**INVITATION TO BID**  
**CITY FUELING FACILITIES IMPROVEMENTS - REBID**  
**B24-PW-101010-500430**  
**ADDENDUM NO. 1**  
**DECEMBER 27, 2023**

**CITY FUELING FACILITIES IMPROVEMENTS REBID**  
**Project B24-PW-101010-500430 REBID**

**DATED: DECEMBER 26, 2023**

## SCREEN WALL AND FOOTING DETAILS

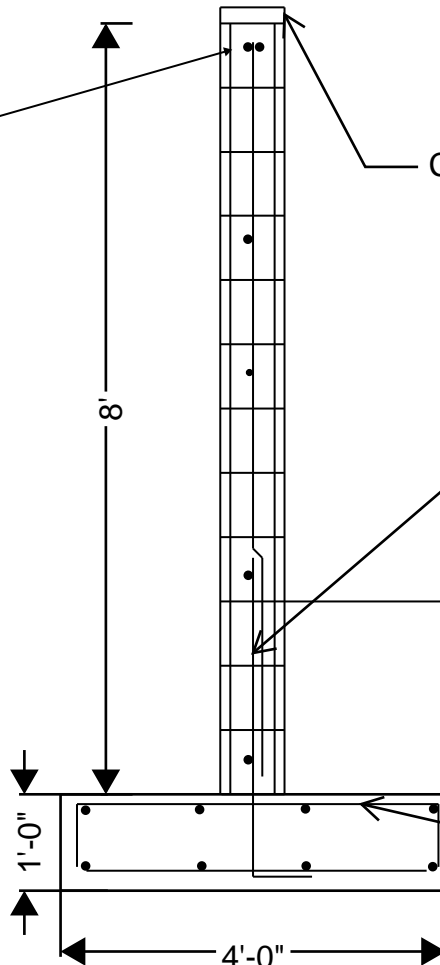
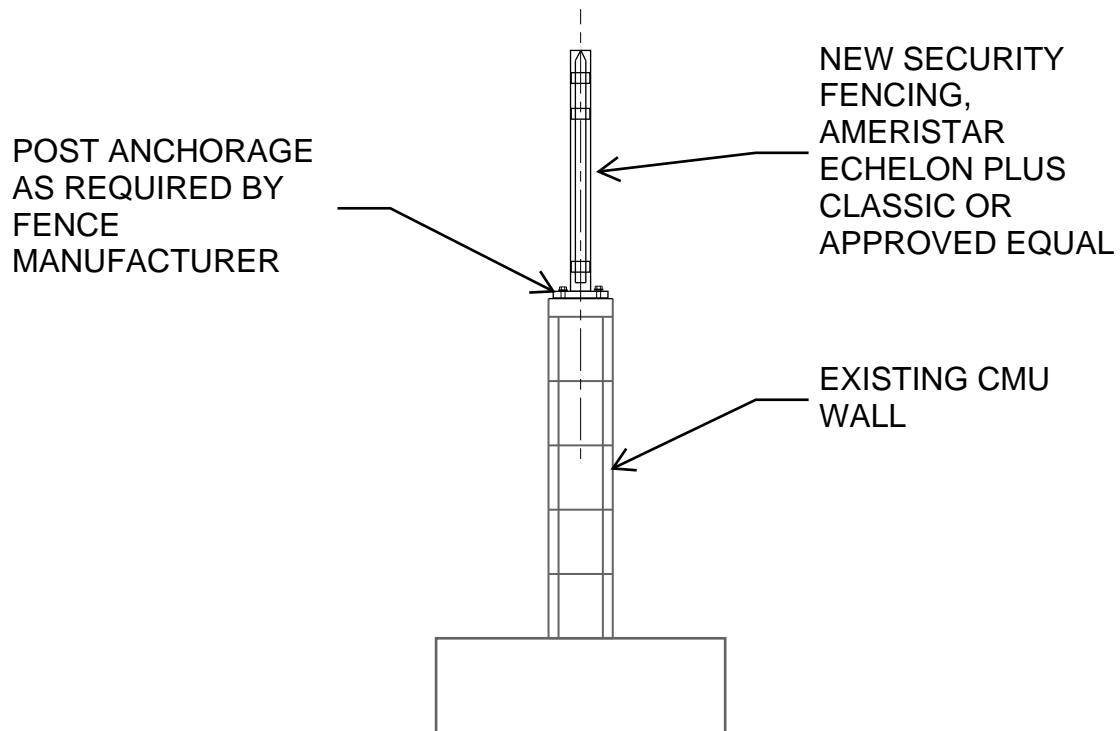
38. **Question:** *Please provide direction for construction of wall types A, B & C shown on drawing C-7. Footing & reinforcement requirements as well as Wrought Iron details. We do have specification 04200 Masonry.*

**Answer:** See attached drawings entitled "Screen Wall and Footing Details".
